LANDSCAPE PLAN

LOT 522 OF A RESUBDIVISION OF LOTS 20, 21 & 22

JEFFERSON PARK
(#413 WEST WINDSOR AVENUE)
CITY OF ALEXANDRIA, VIRGINIA

## FW: FW: Landscape sheets

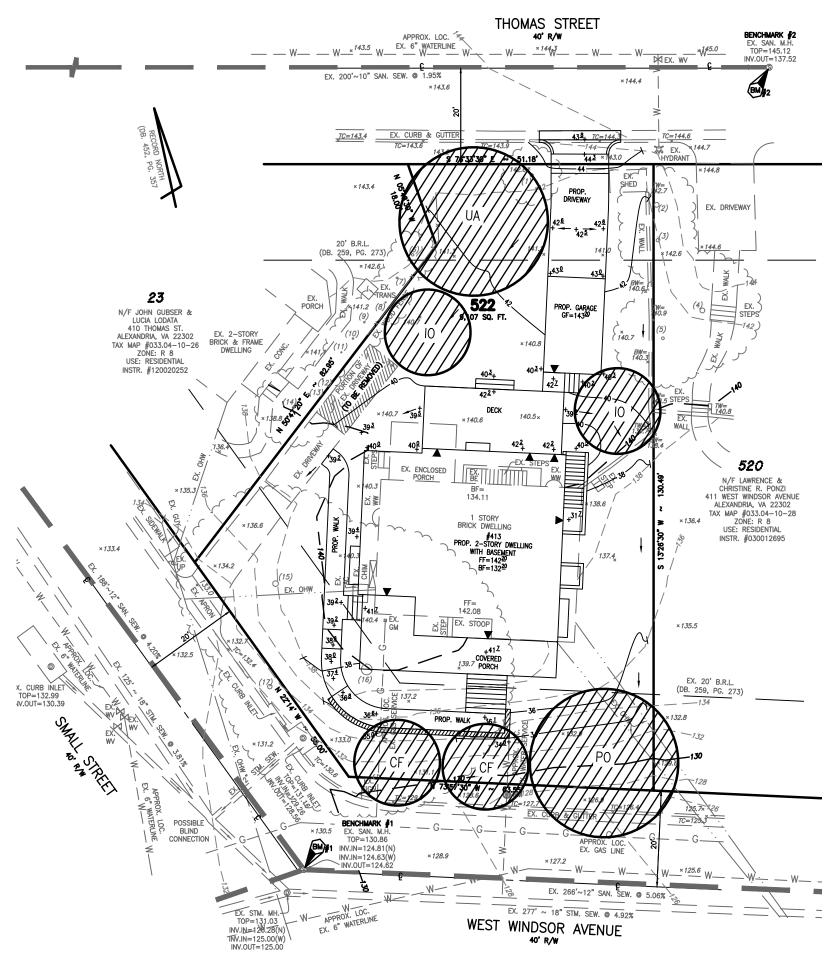
The document you attached to your note of this morning is the same to which we objected yesterday. Apparently, you sent us the wrong edition of your landscape plan.

- Four canopy trees with a minimum 12 feet in height. Two in the front of the new home, two in the back, plus two additional trees to be planted at a location determined by the NRCA.
- The four trees to be planted on the property, as well as the two to be planted elsewhere by NRCA, should be selected from the following list of indigenous canopy trees suitable for smaller Alexandria lots: scarlet oak, white oak, black oak, northern red oak, or black gum.
- The Virginia Pine and milling of the existing white oak would be exchanged for an additional canopy tree.
